Quality Control Check Report. Stage: After Finishing Stage III (Apartments)

MAYFLOWER PLATINUM

Details of Additions & Alterations

Flat No	808	Block no.	'A'
Flat Area	1800 sft	Type	Deluxe / Luxury
Buyer Name	Sandhya Rani Nara		
Phone No.	+15102948991/ 9247802054	Email	ganesh.nara1962@gmail.co:

Changes in flooring:

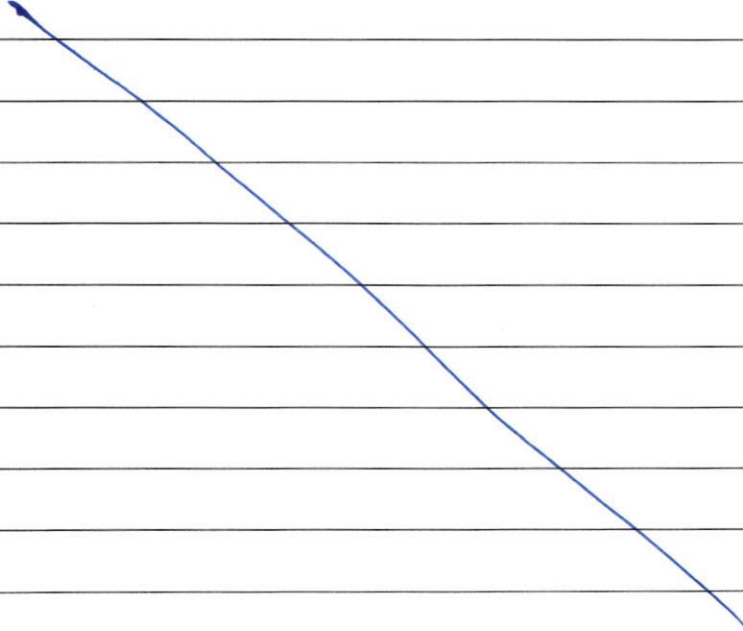
- 1) Same as To be decided later (drawing & Dining) → classic dye
- 2) 3 Bedroom same as model flat (MBR wooden, CBR & GBR 2'x2' vitreous tiles)

ELECTRICAL PLAN OF FLAT-A8

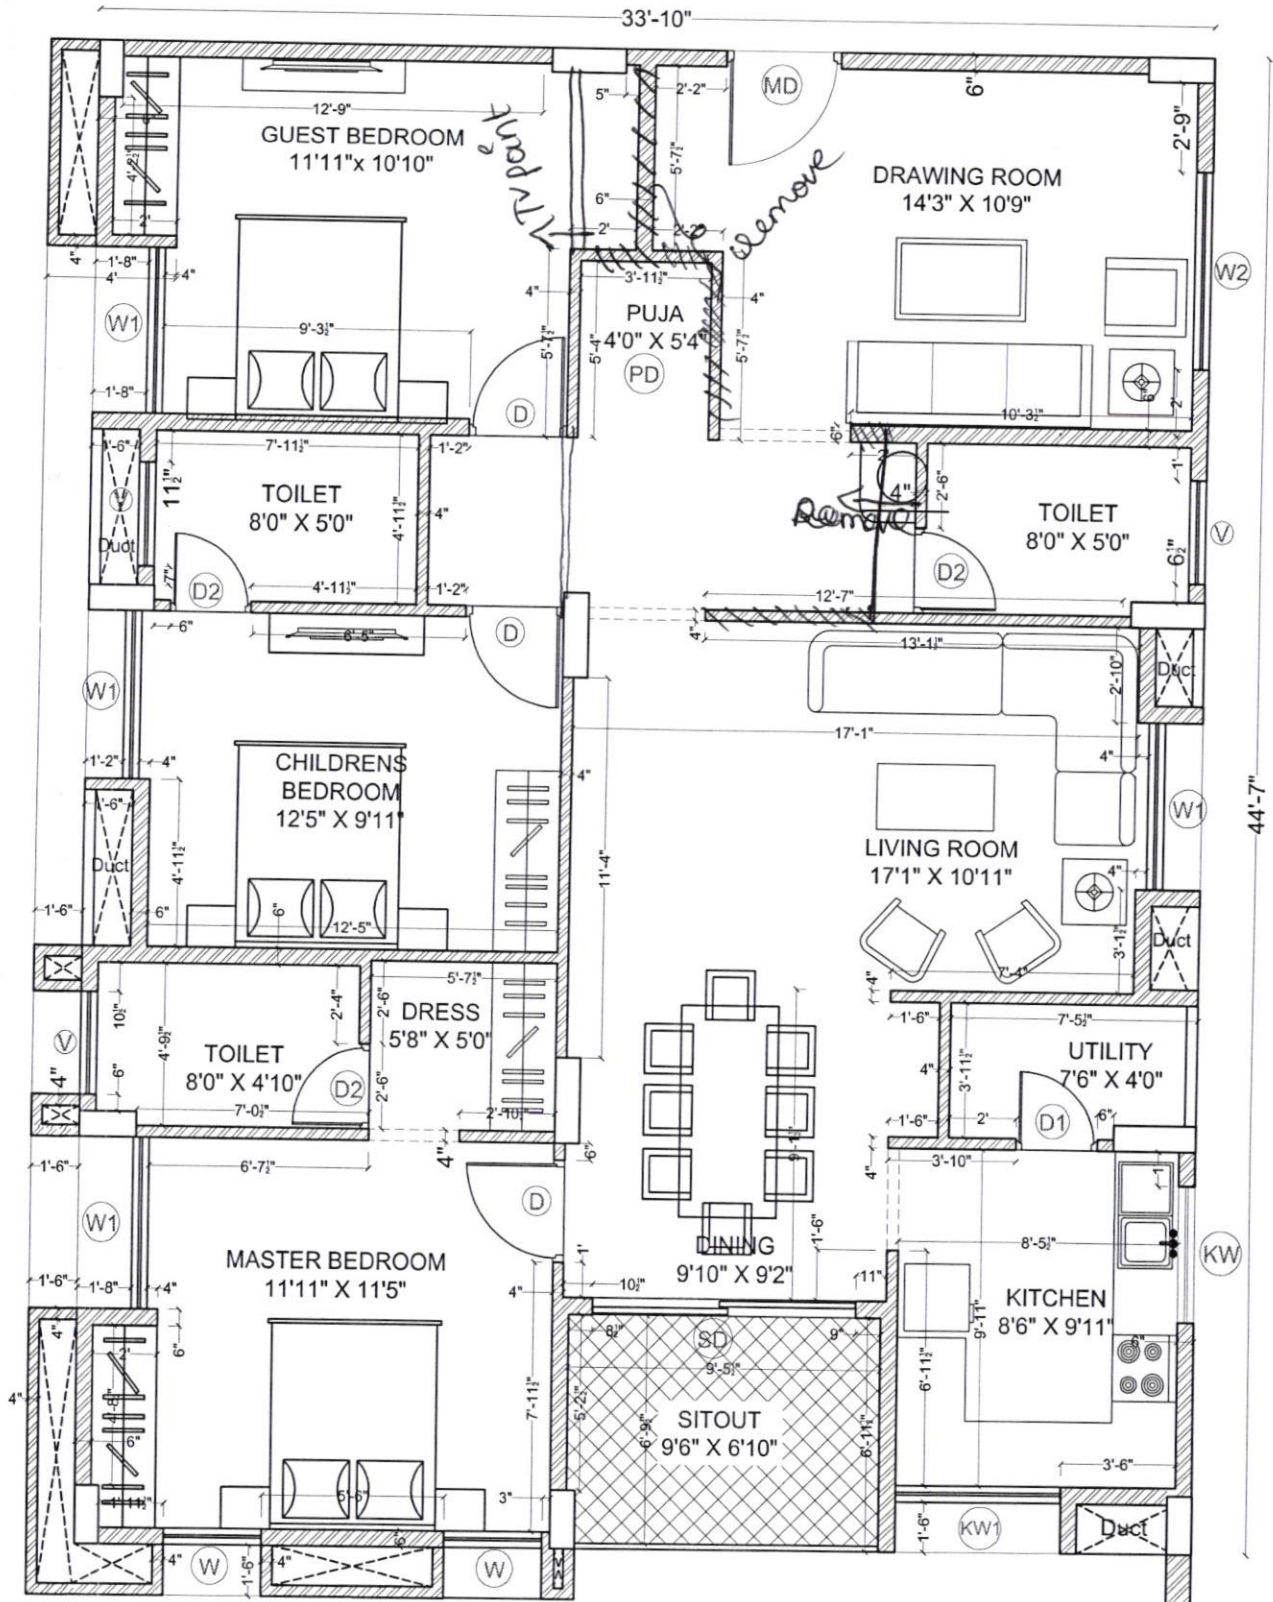
Changes in electrical points: (mark on plan)

Extra TV point at Drawing area.
